AGENDA
REGULAR MEETING OF THE BIRMINGHAM PLANNING BOARD
WEDNESDAY JANUARY 25, 2023 – 7:30 PM
151 MARTIN ST., CITY COMMISSION ROOM 205, BIRMINGHAM MI*

- E.** Unfinished Business
- F.** Rezoning Applications
- G.** Community Impact Studies
- H.** Special Land Use Permits
 - 1. **34350 Woodward – Fred Lavery Porsche – Request for Special Land Use Permit for New 3-Story Auto Sales Agency**

- 2. **479 S. Old Woodward – Birmingham Tower – Request for Special Land Use Permit for New 5-Story Mixed-Use Building.**
- I.** Site Plan & Design Reviews

SUBJECT: 34350 Woodward & 909-911 Haynes Street - Fred Lavery Porsche – SLUP Amendment and Final Site Plan and Design Review

- NOTES:**
1. STANDARD LIGHT REFLECTANCE VALUES: 80% CEILING, 50% WALLS, 20% FLOORS.
 2. TYPICAL CALCULATION PLANE HEIGHTS ARE INDICATED BY FLOOR BEING AT 0'-0" AND WORKPLANE BEING AT 2'-6".
 3. LUMINAIRES SHOWN ARE BASIS OF DESIGN.

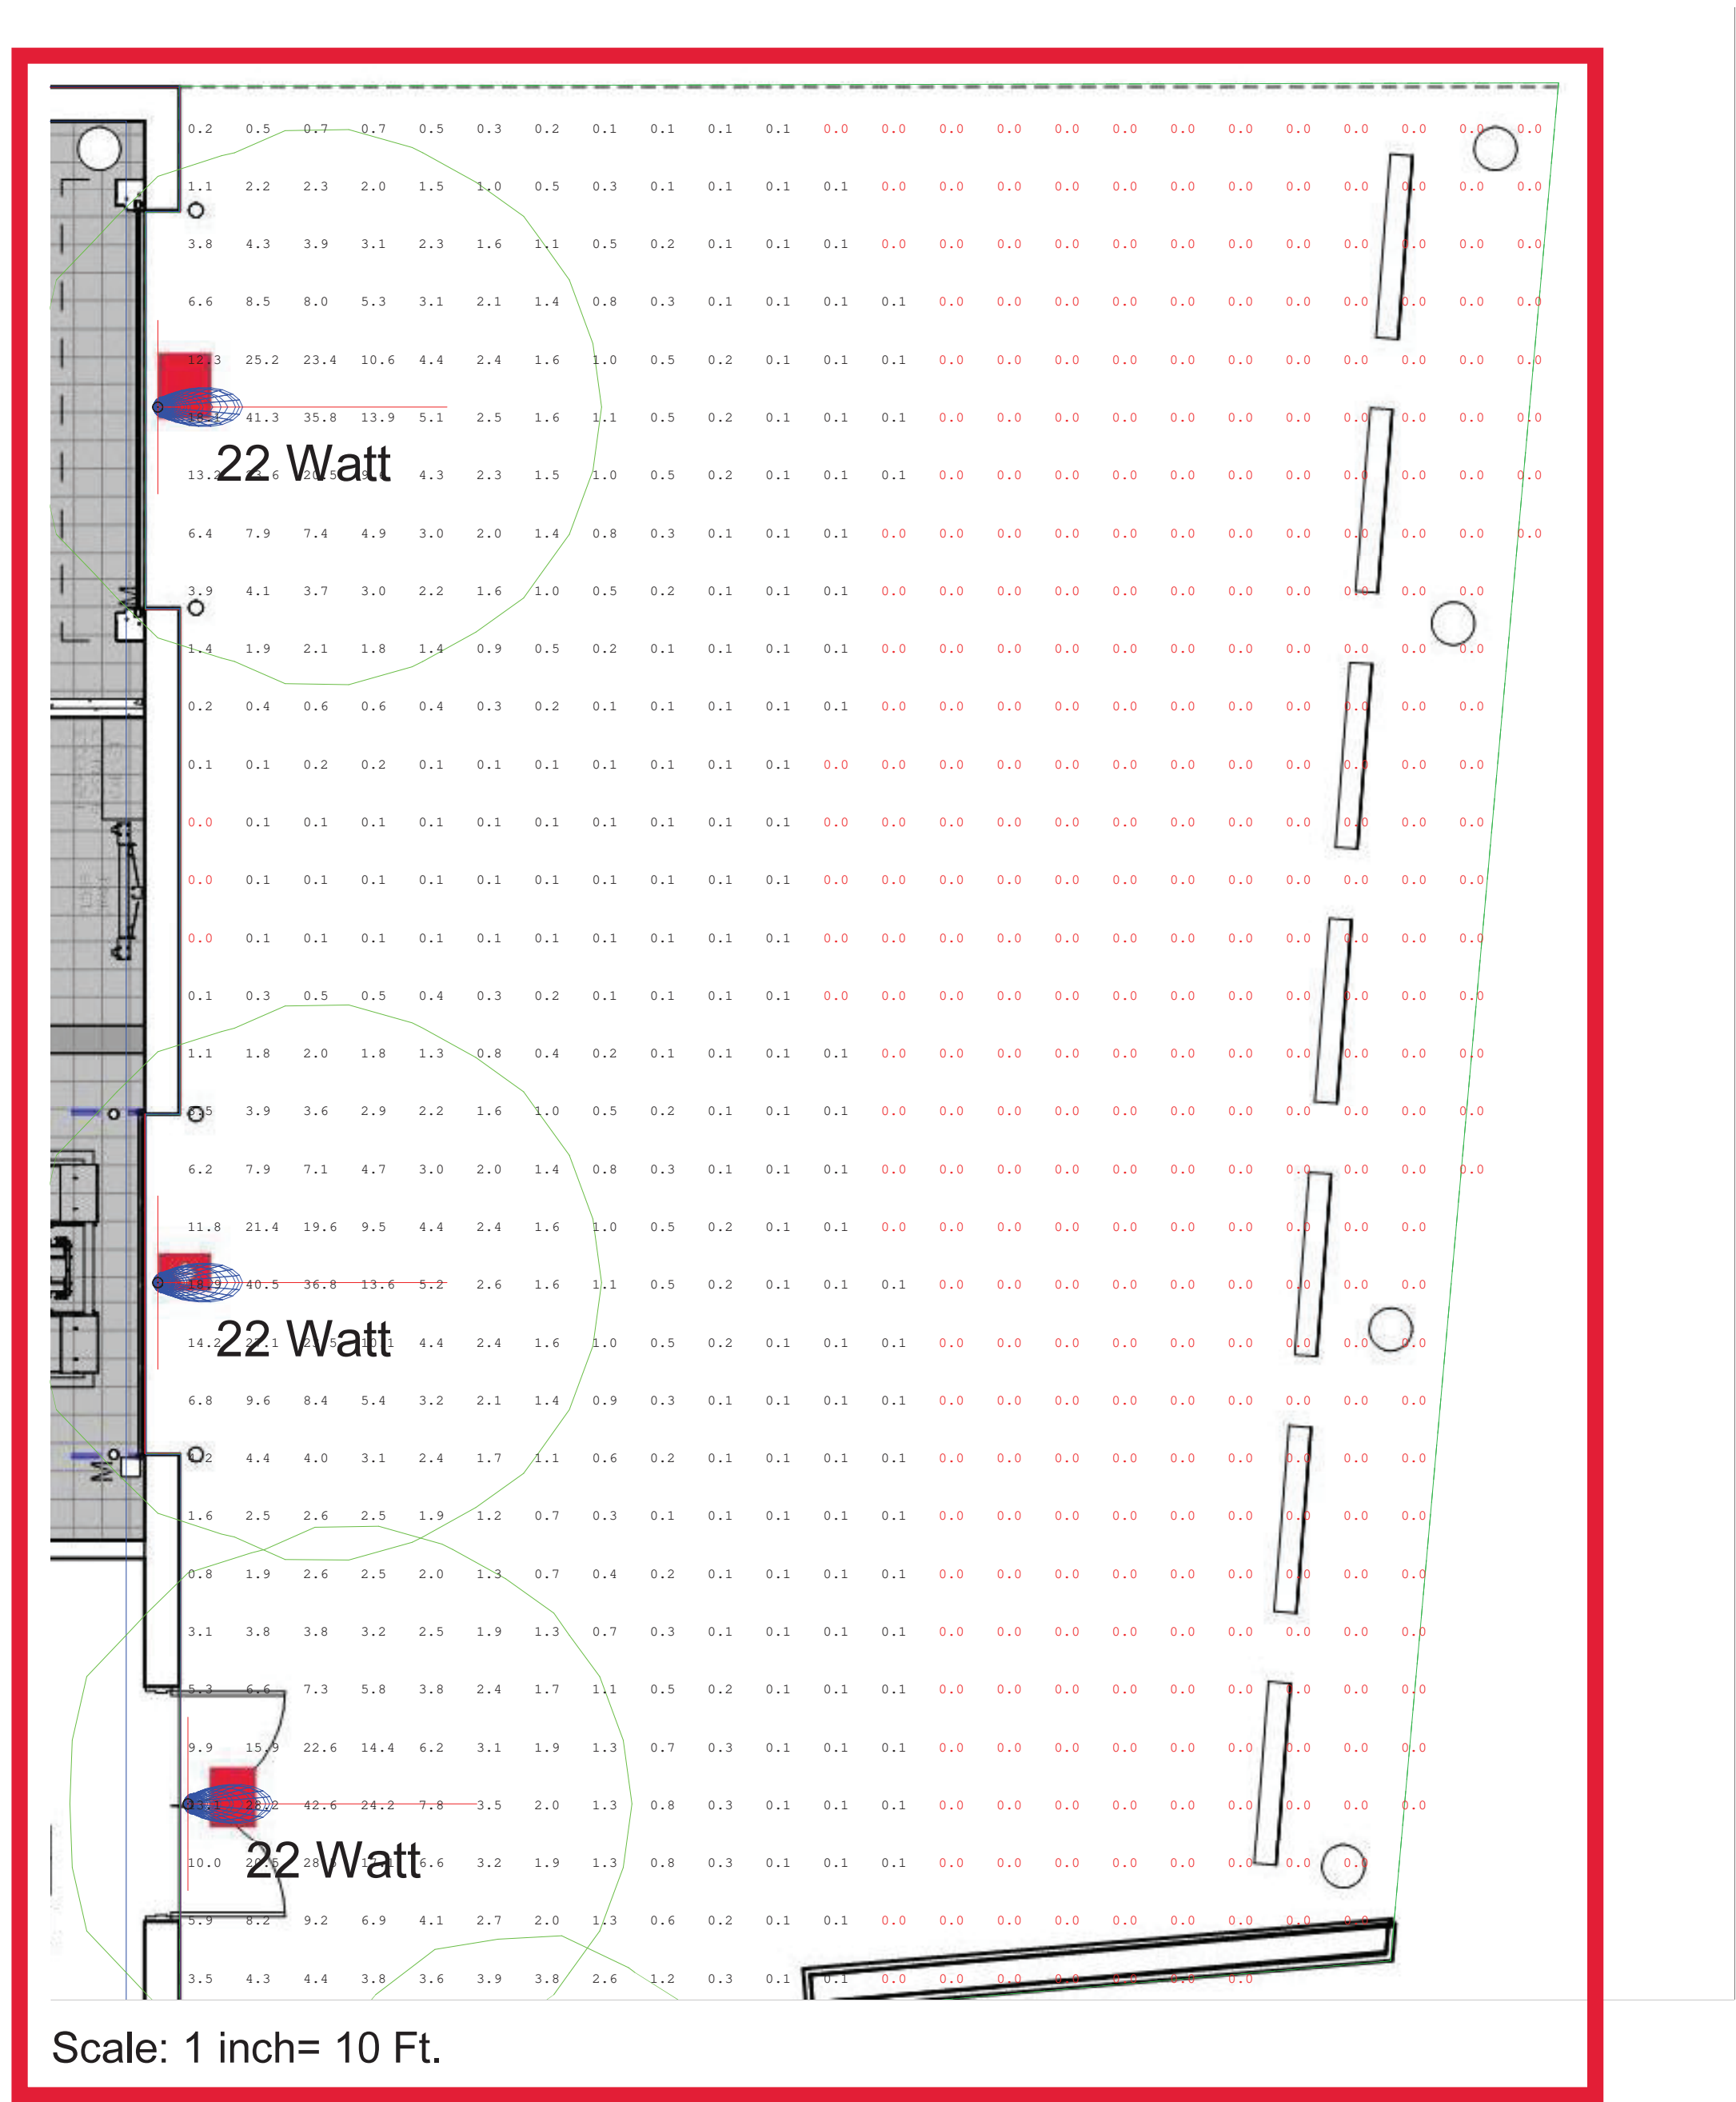
The applicant is proposing twelve exterior light fixtures. Eight lights are proposed to face the street frontage of Elm and Haynes Street, two exterior lights will face the eastern parking lot, and one exterior light is proposed in the exterior. The exterior light fixtures pictured on the elevations labeled AS-1 appear to be cut-off fixtures and are labeled as Bega exterior lighting fixtures, however the plans do not appear to provide a detailed specification sheet regarding the type of light fixture. Information such as the watts and lumens have been provided though. **The applicant must provide staff specifications of the exterior lights to verify they are cut off fixtures.**

The applicant has also provided a detailed photometric plan of the site. The lumens do not exceed 1.5 foot candles at any property line. **City staff request that the applicant update the photometric plan to provide a table showing the range of lumen values for the parking circulation area on the east side of the building to verify the lighting requirements for parking lot circulation areas have been met.**

4. The applicant provide updating lighting information regarding the light fixture specifications and the parking lot circulation area lumen values;
5. The Planning Board approve deviations to the architectural requirements of of Section 3.09(D)(1), Section 3.09(B)(2), and Section 3.09(A)(4) to enable the applicant creativity and flexibility in design for a metal exterior, a non-inset front door, and a garage door on the front façade with the condition that the applicant provide a front elevation drawing of the proposed building superimposed on a color drawing or photograph of the entire block showing the relation of the proposed building design to other buildings along the block; and

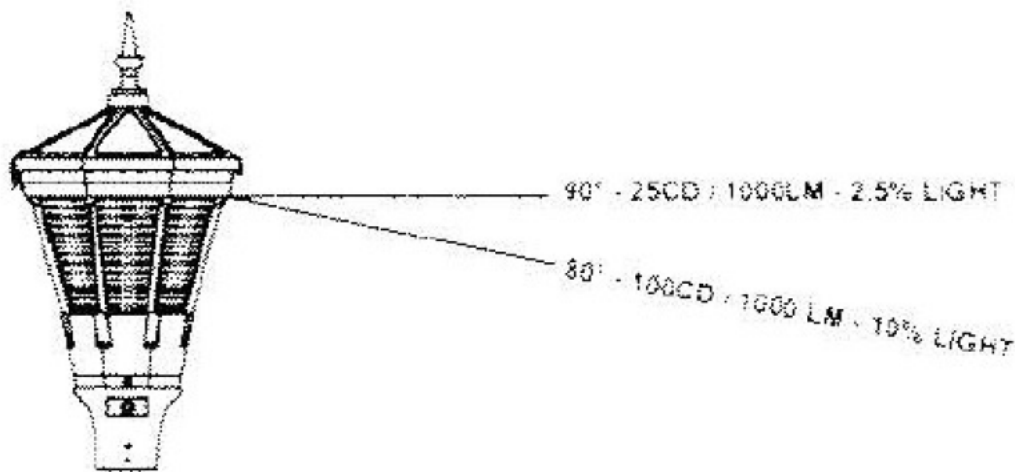
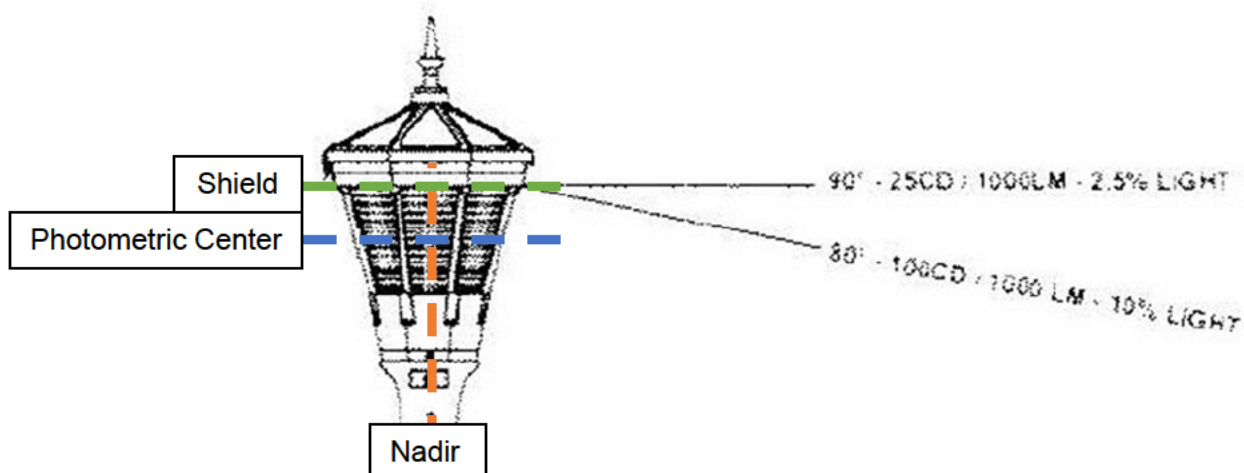
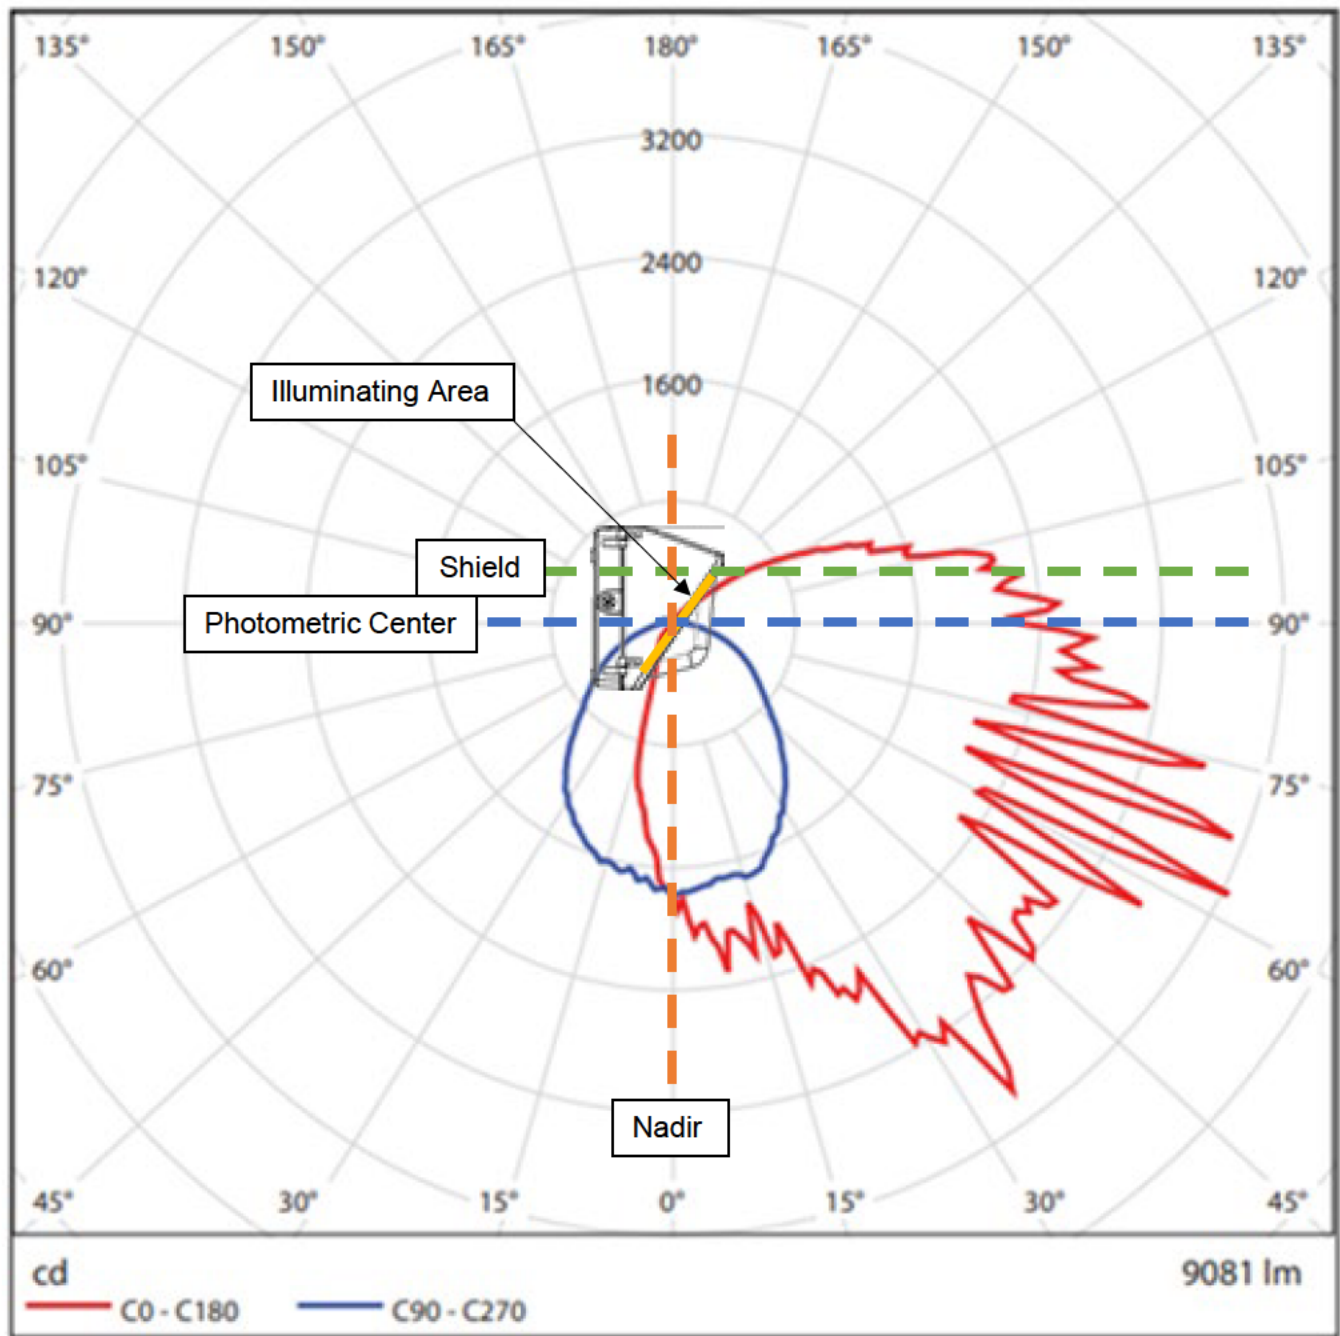
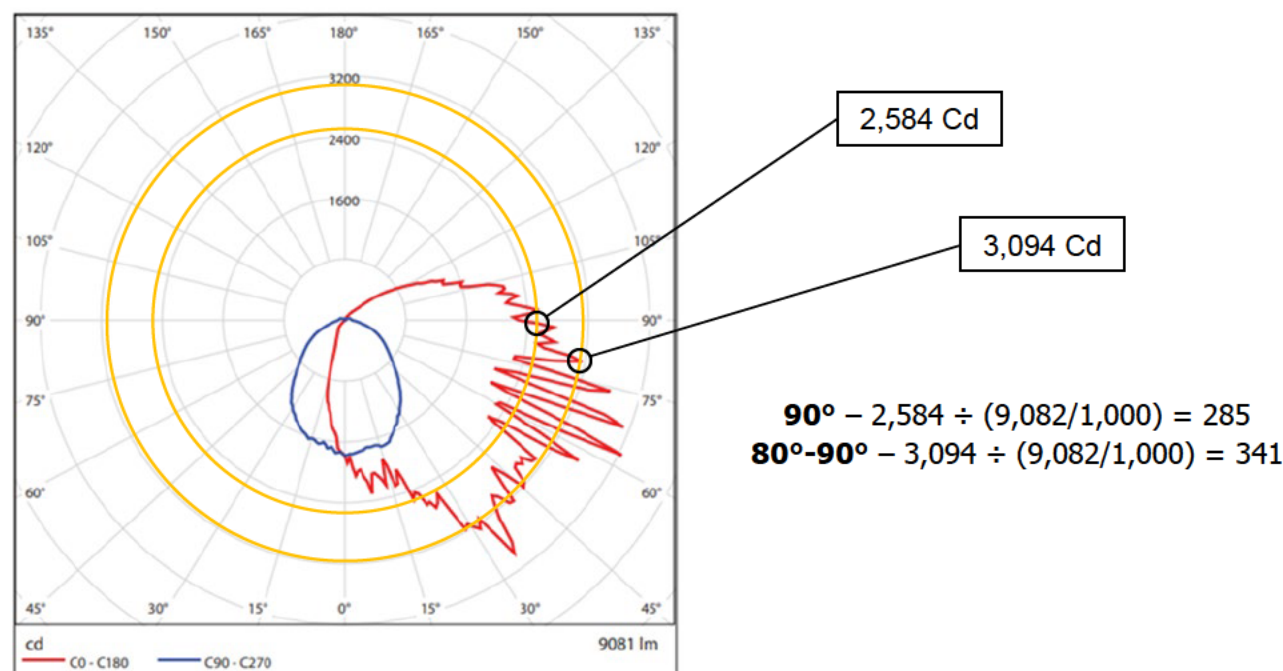
Because we have a better understanding of the placement of the fixture on this polar curve, we can better address the assertions that were made regarding the percentage of light above the 90-degree threshold that is key to determining whether a fixture is cutoff as defined by our Zoning Ordinance. Let us revisit the Zoning Ordinance definition of cutoff, followed by the IESNA definition of cutoff:

Based on the information presented above, we can assign a photometric center to the luminaire depicted in the definitions of cutoff. Notice, though, that the photometric center (blue) may not correspond to the area where the adjacent mathematical considerations in the Zoning Ordinance definition of cutoff are demonstrated. In fairness, because we do not know where the light source is in this particular graphic (it is, after all, just a graphic), we must take into account that the photometric center was considered and is higher (green) in this fixture.

As is apparent by these calculations, these numbers are too high and do NOT meet the cutoff requirements of our Zoning Ordinance (figures greater than 25 and 100, respectively). This would appear the case whether we were to use the **blue** line at the photometric center or the **green** line at the shield from the graphic on the previous page because the equation appears to require the max candela (a single point) at that angle, not the zonal lumen average above the threshold. It is also apparent that the effect of the dimmers that were installed is difficult or impossible to measure and apply in this case. Although dimmers do in fact reduce the power to the fixture, which in turn reduces the brightness (lumens), there is no easy way to extract the figures required to perform the equation that is in the ordinance regulations.
